# Product Change Notification

**Change Notification #:** 116380 - 00  
**Change Title:** Intel® NUC Kit, NUC6CAYH,  
Intel® NUC Kit, NUC6CAYS,  
PCN 116380-00, Product Design, Label,  
Product Material,  
BIOS and Embedded Controller Firmware  
Update, Add GML Label, and Add  
Alternative DDR3L Component  
**Date of Publication:** July 25, 2018

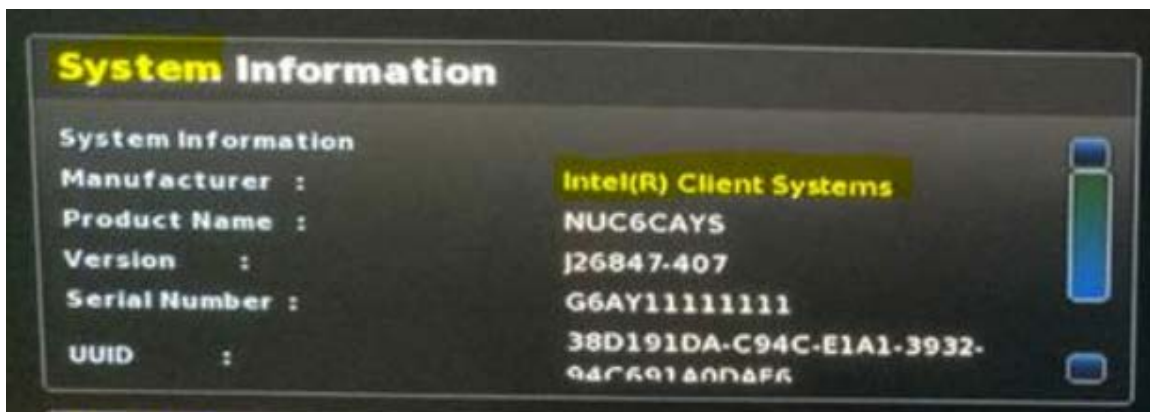
4. Add Microsoft\* GML Label as shown below

5. Change Manufacturer information in SMBios/DMI from "Intel® Corporation " to " Intel® Client Systems" in the Bios Setup Screen as shown below
